From: [Perkins, Matthew](#)
To: karen.walter@muckleshoot.nsn.us
Cc: [Overton, Frank](#); [Lindsey Ozbolt](#); [Peterson, Bob](#); [Brown, Kevin](#); [Auld, Gina](#)
Subject: Letter RE: ELST Segment 2B
Date: Monday, February 13, 2017 1:56:03 PM
Attachments: [February 13 - Letter - Karen Walter - ELST Segment 2B.pdf](#)
[Attachment 1.pdf](#)
[Attachment 2.PDF](#)
[Attachment 3.PDF](#)

Thank you for submitting comments pursuant to the East Lake Sammamish Segment 2B Shoreline Substantial Development Permit (SSDP2016-00415). I am sorry to hear that there was difficulty in accessing some of the supporting information. I am recapping some of our previous communications in this letter, providing updated links to some of the files for review, and offering another opportunity to meet to go over all of the information.

EAST LAKE SAMMAMISH MASTER PLAN TRAIL SOUTH SAMMAMISH SEGMENT B
 SAMMAMISH, WA

SHEET NO.
42 OF 135
AL10

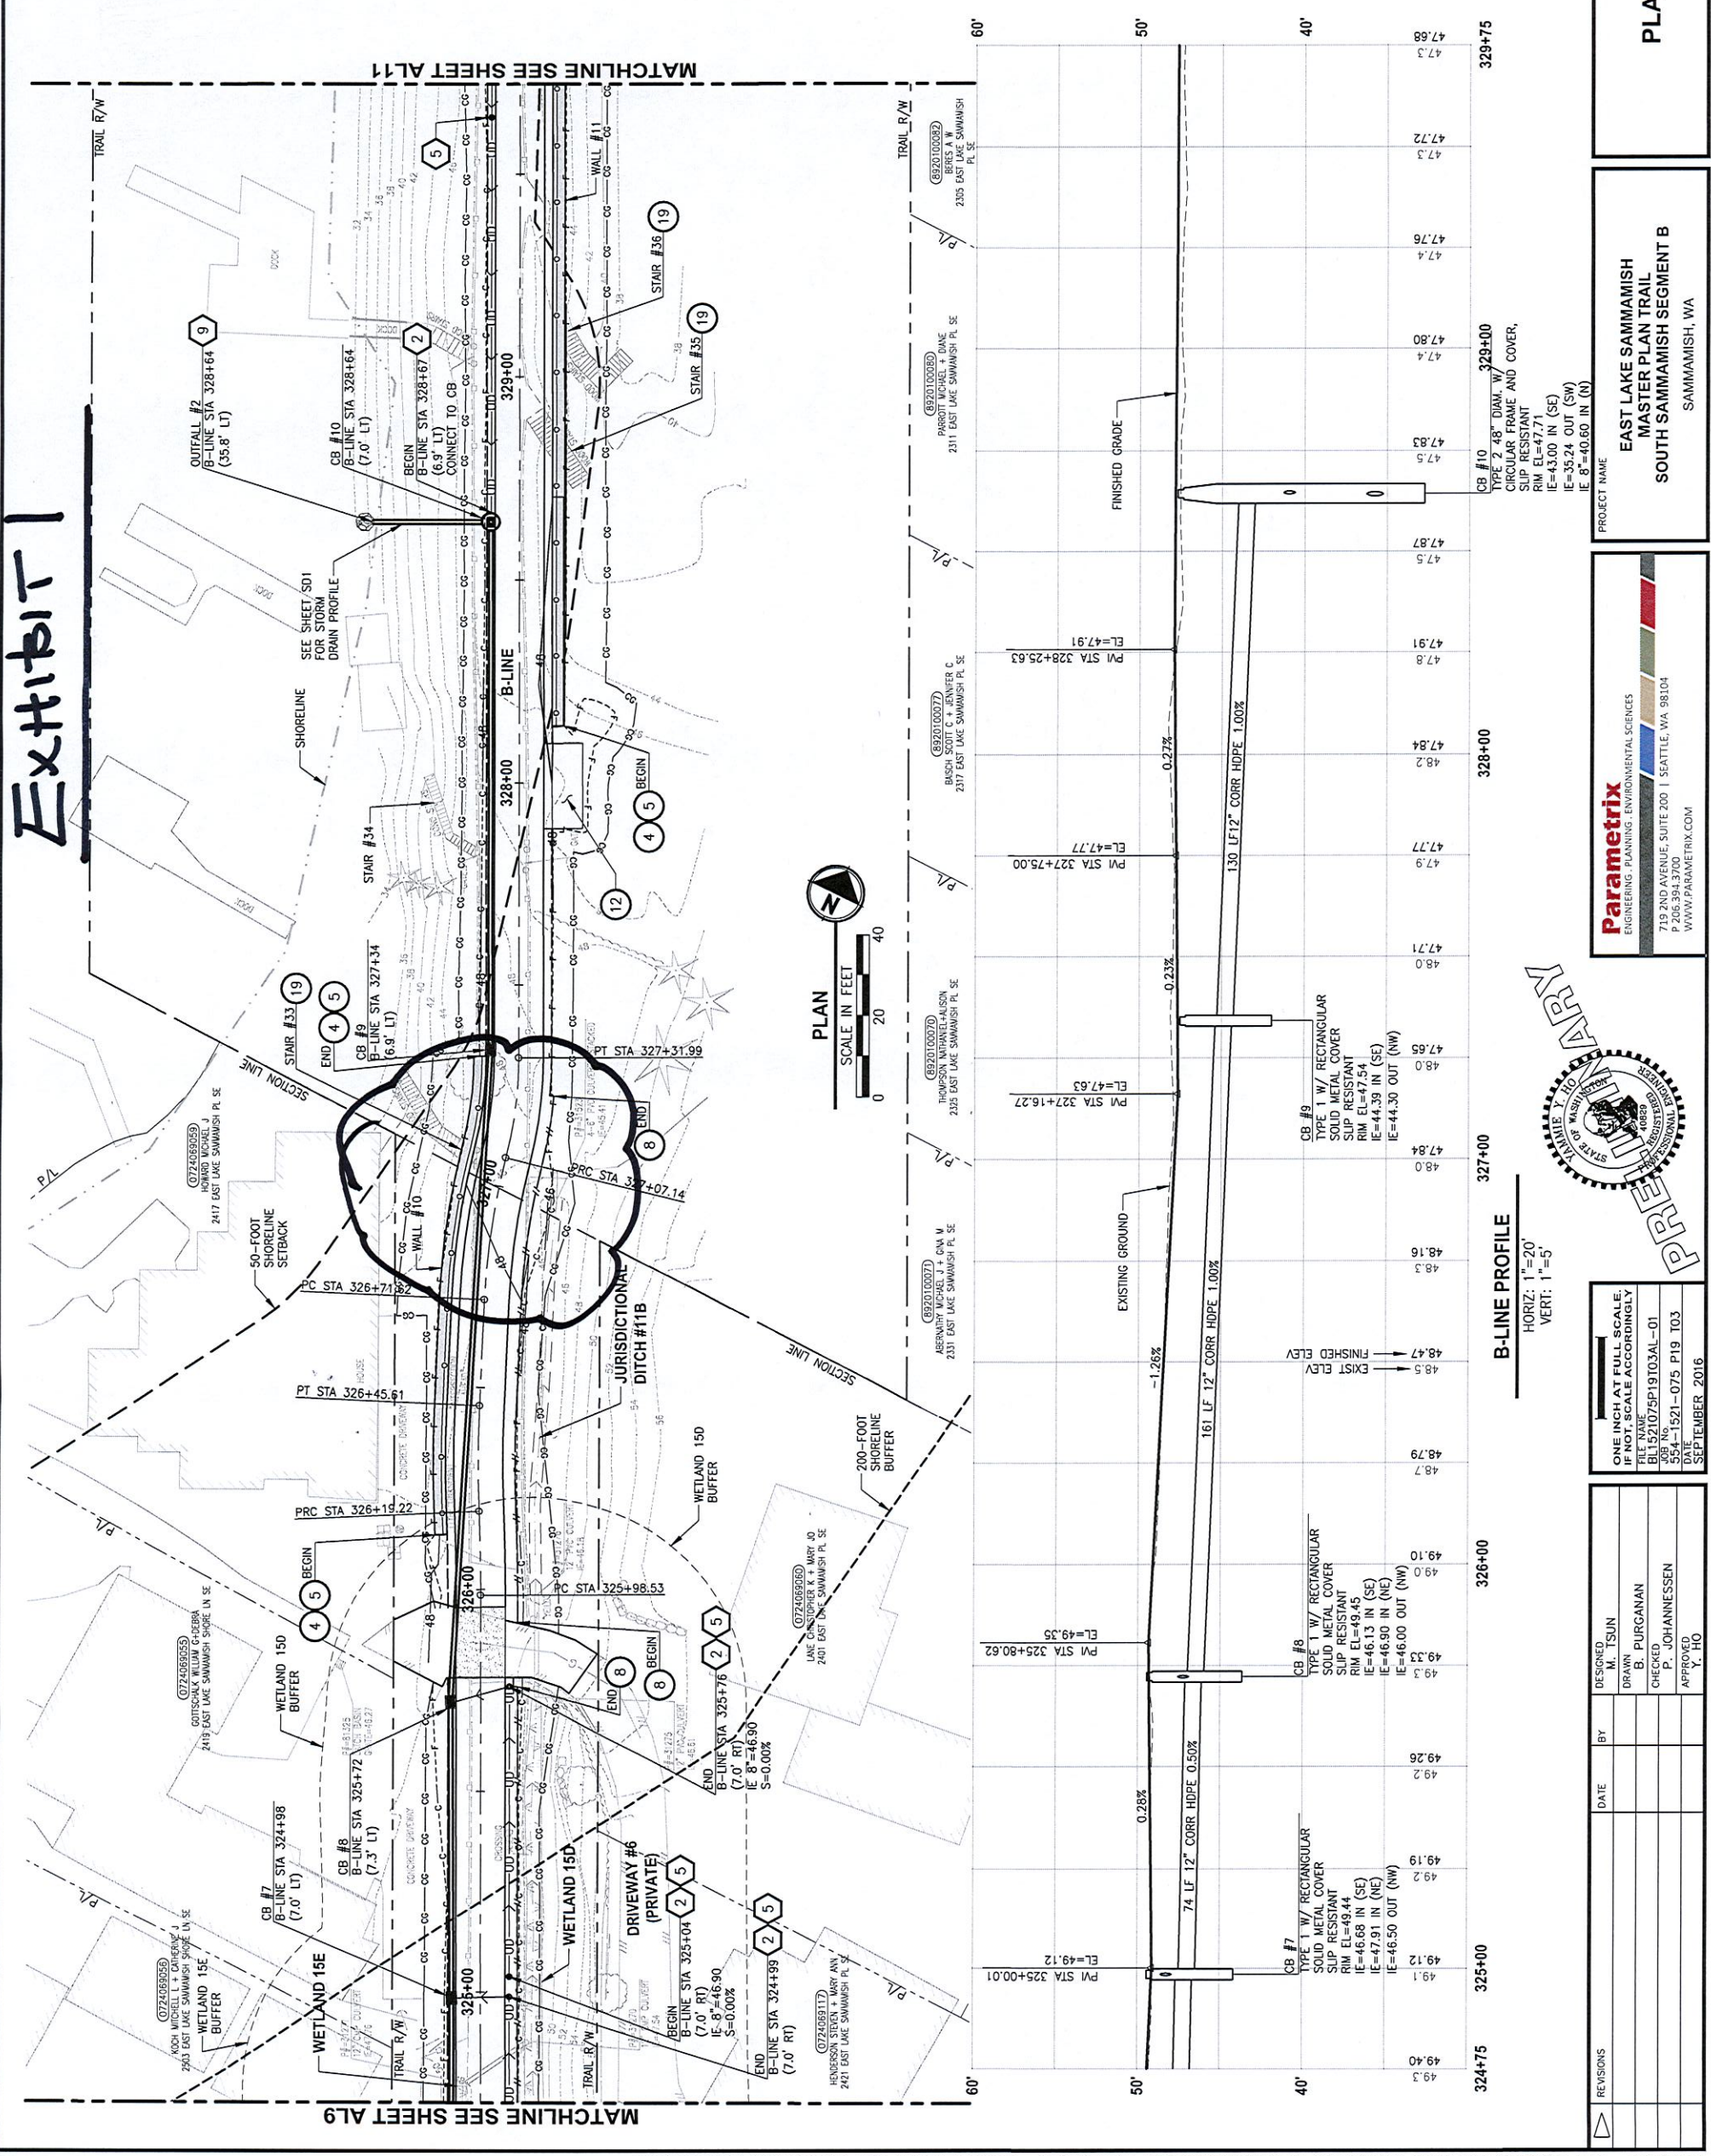
Per the Preliminary Plans, it appears that the County is unnecessarily realigning the centerline of the Trail waterward (*i.e.*, closer to my clients' residences).² Notably, the County has previously published the criteria that it employs to determine if the existing centerline of the Trail should be realigned, which include the following: (1) "[m]inimizing costs where possible without impacting trail standards," and (2) "[m]inimizing impacts to adjacent homeowners."³ As explained in greater detail below, it does not appear that the County's proposed realignment complies with either of these criteria.

The existing elevated Trail corridor currently acts as a berm that collects surface water behind it during extreme weather conditions. This problem is exacerbated by excess hydraulic water pressure from Jurisdictional Ditch #11B and runoff from nearby impervious surfaces, including the existing semi-permeable gravel Trail.⁵ Although the Preliminary Plans depict the existence of four, 6-inch culverts located near the north end of Jurisdictional Ditch #11B,⁶ these culverts do not currently provide an outlet for the ponding water. Instead, because the ponding water currently has no outlet, it builds hydraulic pressure that adversely affects the foundations and sewer systems of both the Gottschalk and Greve residences. This hydraulic pressure has led to water infiltration through the foundations and into their respective residences.

- **Retaining Wall #10** – My clients' preferred alignment would allow for Retaining Wall #10 to be moved east, closer to the alignment of the Trail, which could then be reengineered to be either a smaller retaining wall, or be eliminated altogether as a result of existing elevations. This common sense change would result in considerable savings to taxpayers.⁸

SHEET NO. 14 OF 135
 EX6

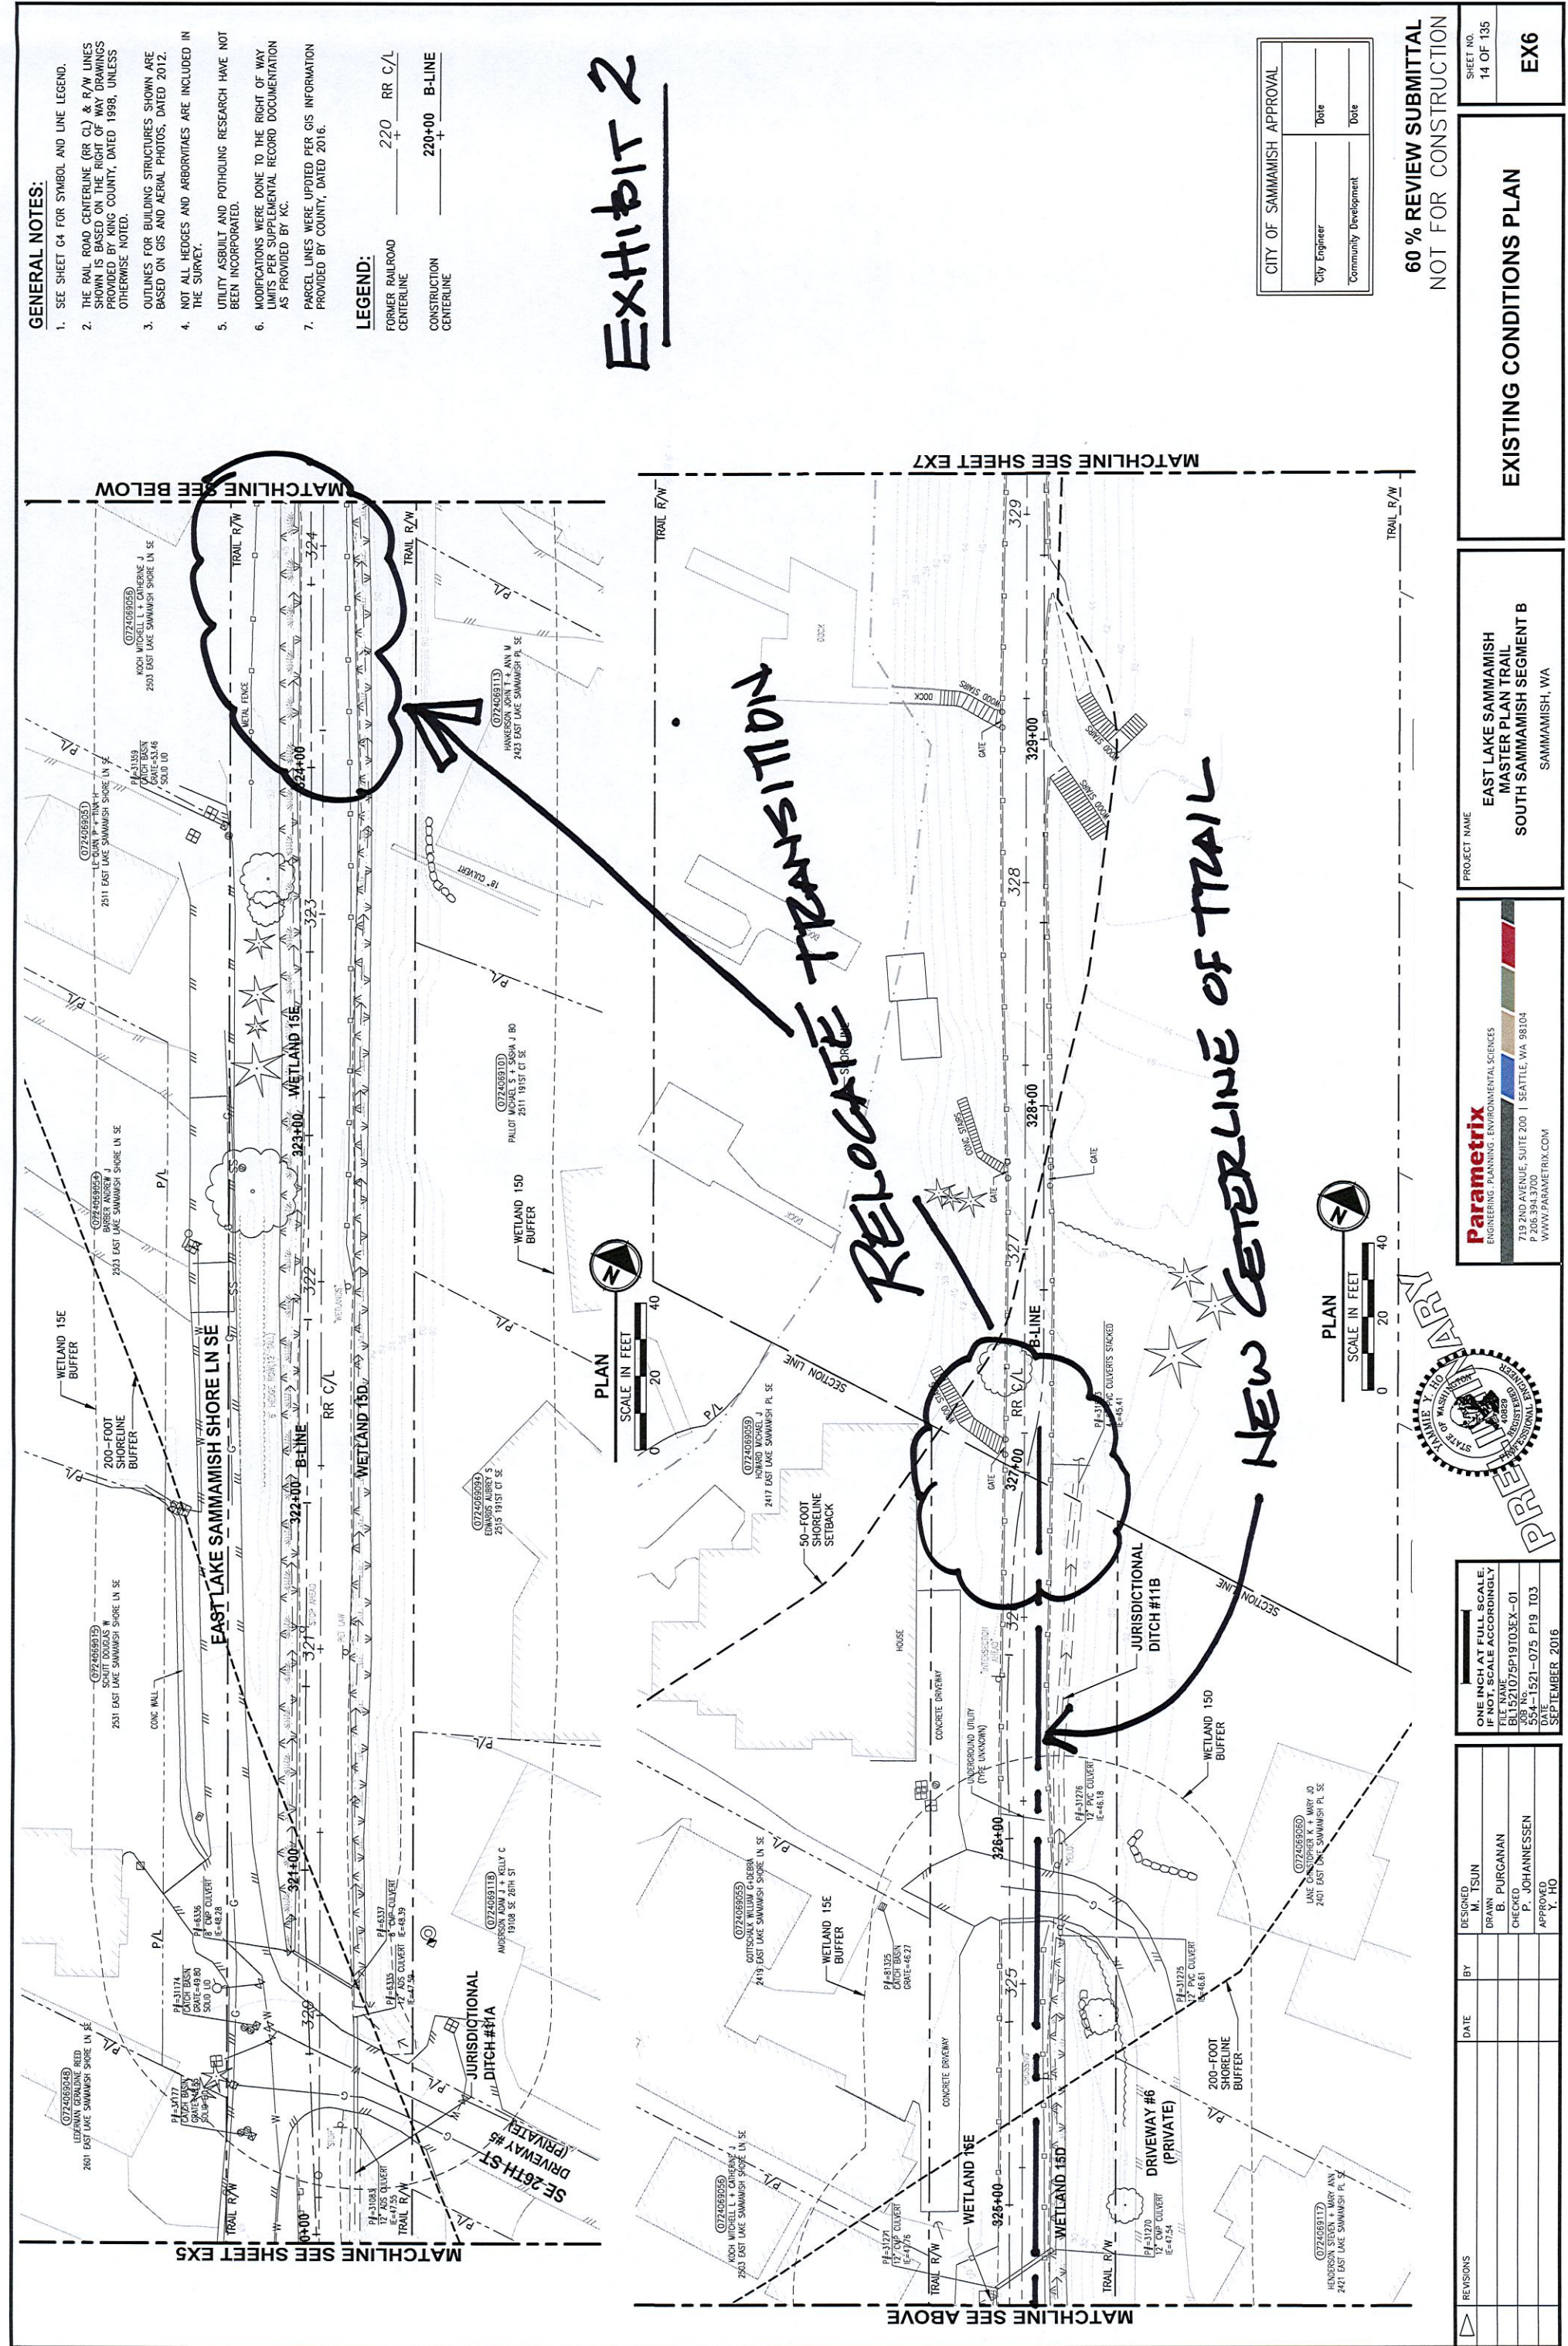
- **Clearing and Grubbing Limits** – My clients also propose that the clearing and grubbing lines be modified to correspond to my clients' preferred Trail realignment. My clients' proposed modifications are depicted on the attached Exhibit 3. Further, the clearing limits should be adjusted to follow the course of the Trail in order to prevent and/or limit, any adverse impacts to my clients' existing stamped concrete driveway, irrigation, drainage, and landscape lighting.
